CITY OF LA VISTA
MAYOR AND CITY COUNCIL REPORT
MAY 16, 2017 AGENDA

Subject:	Type:	Submitted By:
REZONING AND PUD SITE PLAN APPROVAL — LOT 2, HARRISON HILLS (SW OF 118 TH STREET & HARRISON STREET)	RESOLUTION ◆ ORDINANCE (2) RECEIVE/FILE	ANN BIRCH COMMUNITY DEVELOPMENT DIRECTOR

RECOMMENDATION REPORT

CASE NUMBER: PPUD-17-0002

CREATE UNDULATING BERMS
OF
VARYING HEIGHT IN THESE
AREAS

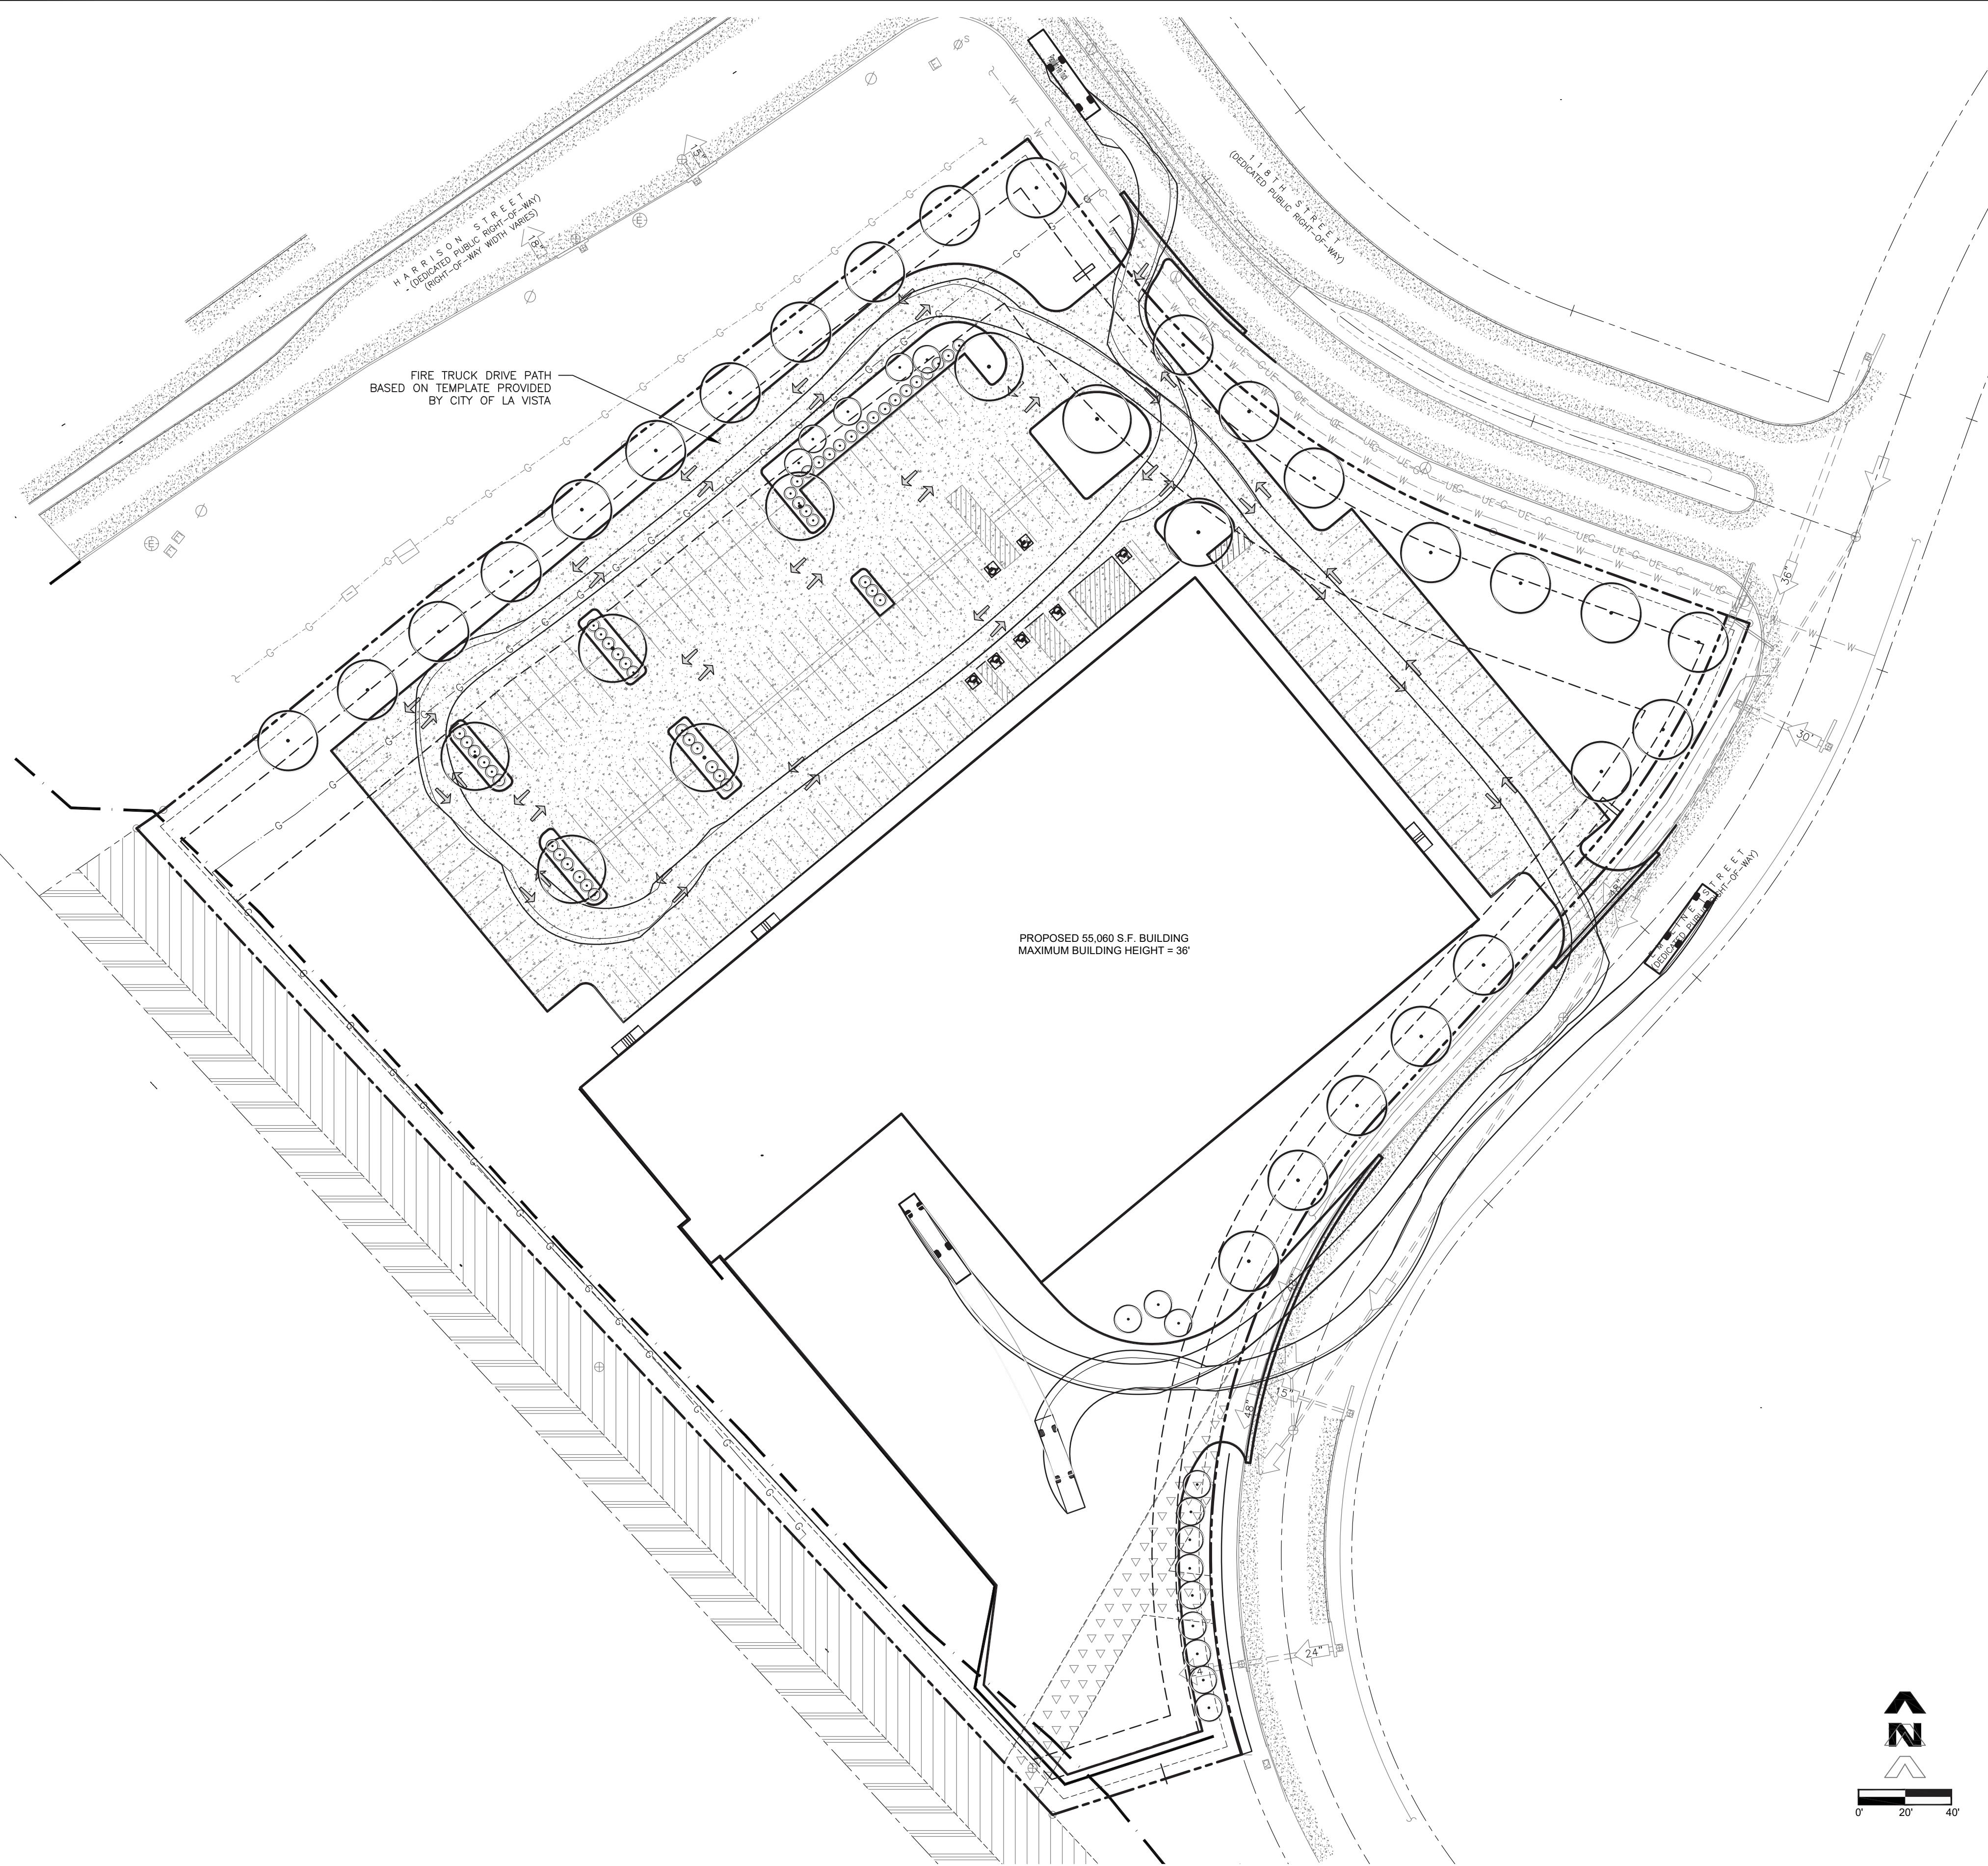
I've reviewed the revised PUD site drawings and of the 3 original major concerns only 1 has been fully addressed.

- 1) The visual screening of the dock areas from the road has been addressed with coniferous trees.
- 2) Undulating site forms are showing up on the grading plan at the southeast side of the building and some of the northeast corner lawn areas, but there is nothing indicated along the northwest property line. This area is likely going to be too narrow to do much with varied topo lines, so mounded berms would be recommended.
- 3) The plant species indicated and sizes have not been revised and many are still not compliant.

DATE
JOB NO. 16356
EMERGENCY VEHICLE TURNING
SHEET NO.

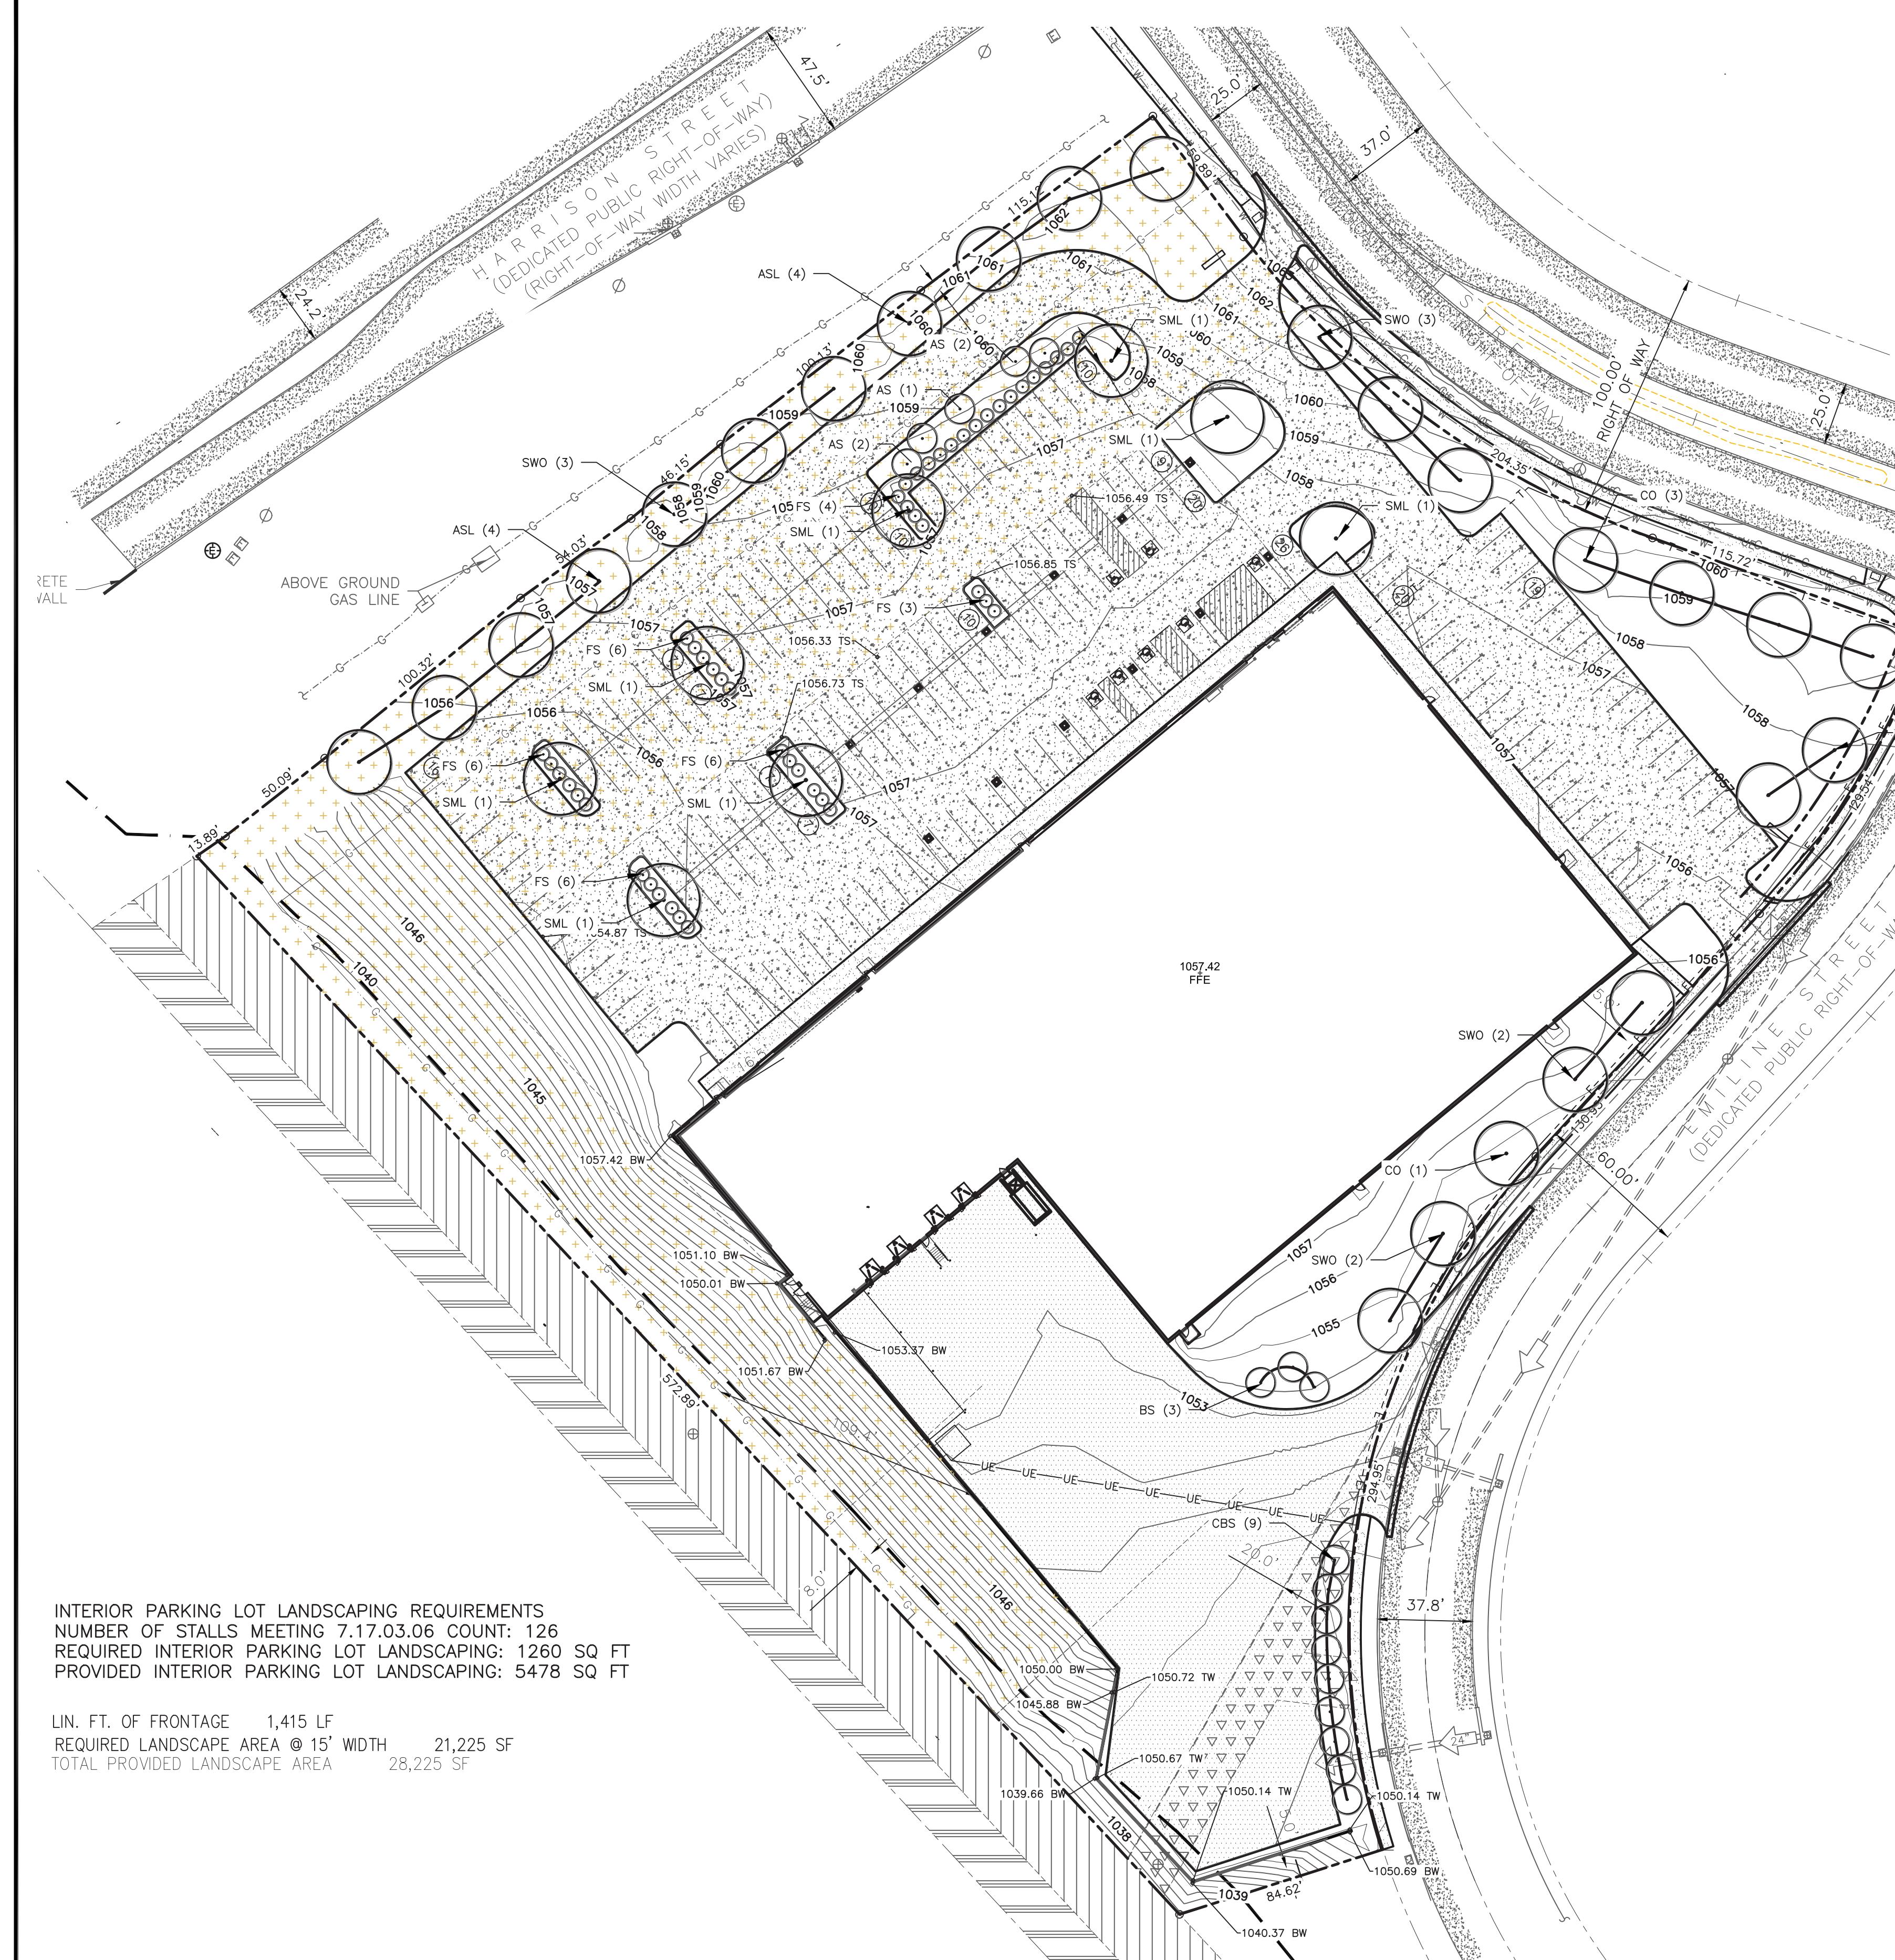
9. The call-out for the equipment screening wall on the Emergency Vehicle Turning plan is pointing to the wrong location.
10. The Papillion Fire Marshal's office has prepared a memo regarding the Emergency Vehicle Turning plan. It is attached for your review.

After having reviewed the Restaurant Depot plan set I am not satisfied with the depiction rendered for the emergency vehicle turning radii. The path they show does not even approach the building. It appears to me that the large island just inside of the 118th St. entrance will pose a problem for apparatus access, especially if cars are parked in the lot.

10. Fire Marshals' Review Letter – We have adjusted the Vehicle Turning Plan to show the path through the site allowing access approaching the buildings.
